IEC 61924-2
(First edition – 2012)

**Maritime navigation and radiocommunication equipment and systems –
Integrated navigation systems –
Part 2: Modular structure for INS –
Operational and performance requirements, methods of testing
and required test results**

CORRIGENDUM 1

Clause K.2 ACM – Alert command

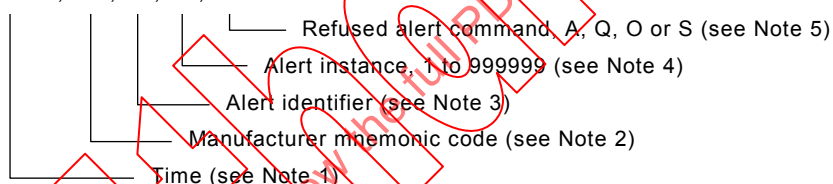
Replace, in the title and the sentence definition (fourth paragraph) ACM by ACN as follows:

K.2 ACN – Alert command

\$--ACN,hhmmss.ss, aaa, x.x, x.x, c, a*hh <CR><LF>

Figure J.3 – Alerts' communication showing priority reduction

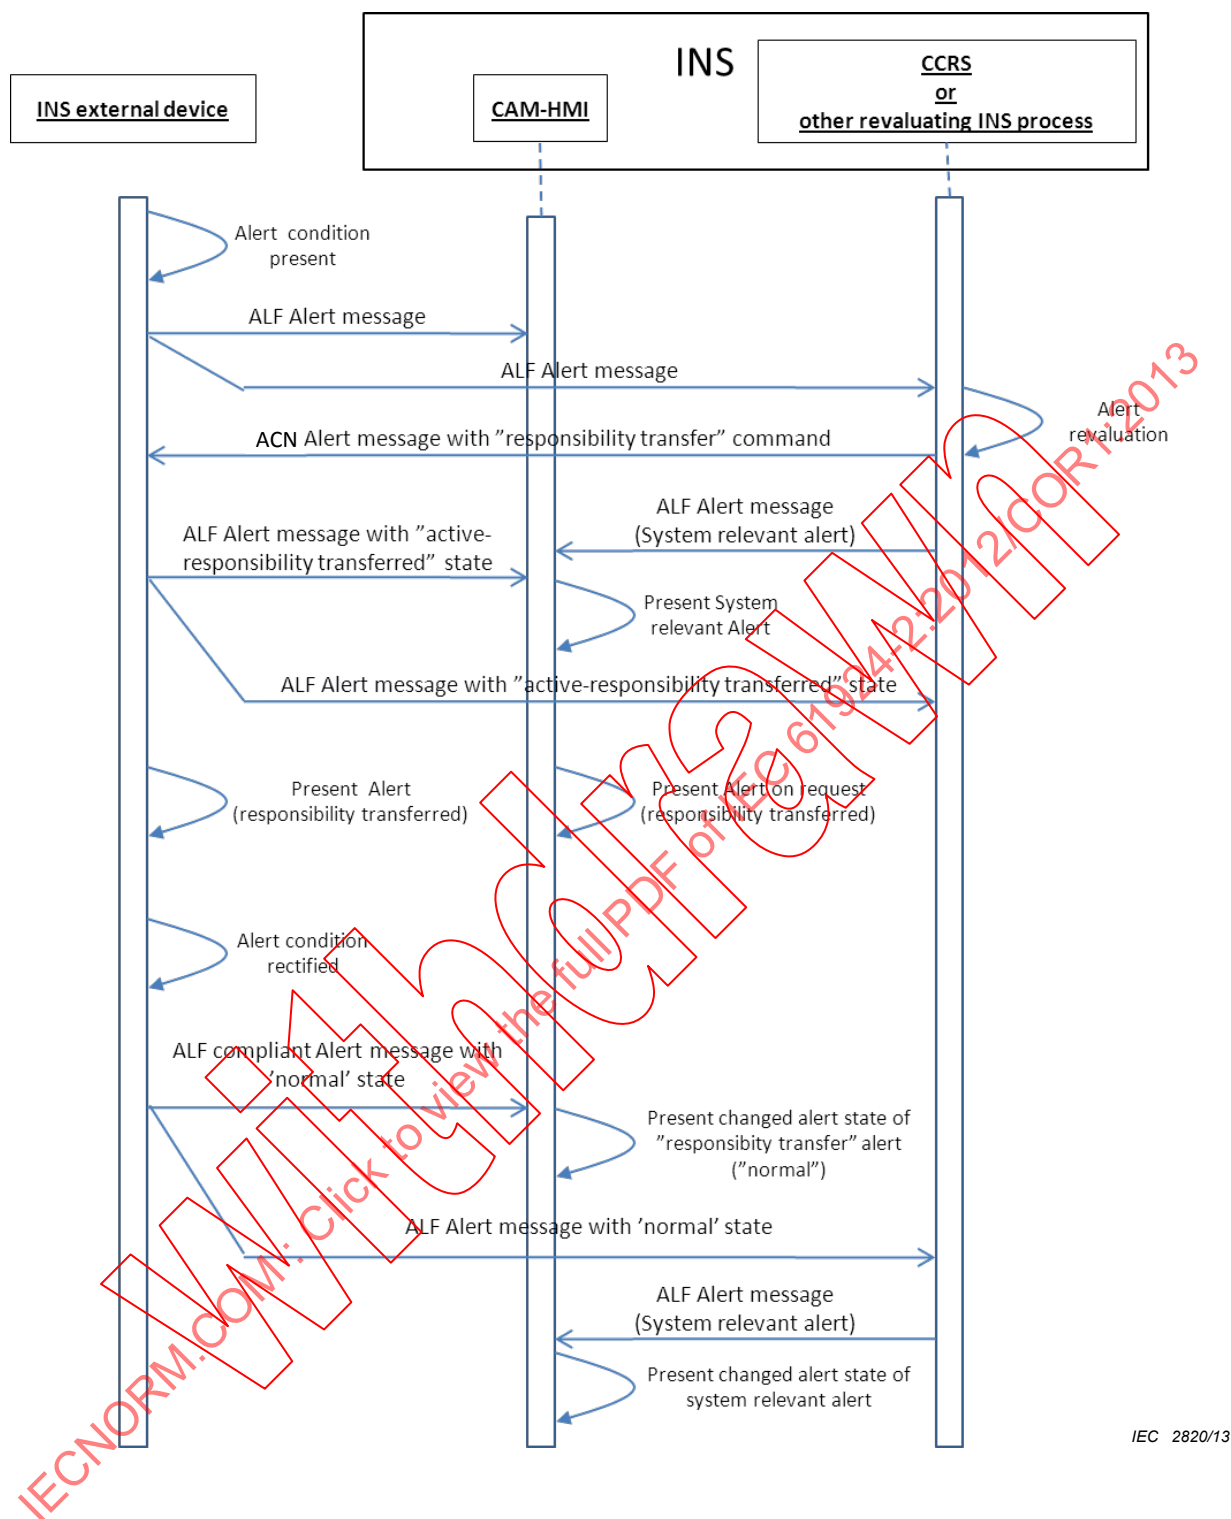
Replace ACM by ACN in the following clauses, subclauses, tables and figures:

J.3.2	1 st paragraph	
Table J.1	6 th row	
Table J.1	7 th row	
Table J.2	Title	
Table J.2	1 st row, column title	
J.3.2	example below Table J.2	1 occurrence
Figure J.1		1 occurrence, see below
J.3.3	1 st paragraph, below Figure J.1	
J.3.4	1 st paragraph, below Figure J.2	
Clause J.4	Title	
J.4.1	1 st paragraph	2 occurrences
Figure J.3		1 occurrence, see below
Figure J.4		1 occurrence, see below
J.4.6	Title	
J.4.6.1	1 st paragraph	
J.4.6.2	1 st paragraph	
Figure J.5		8 occurrences, see below
Clause K.3	2 nd paragraph	
L.1.1	1 st paragraph
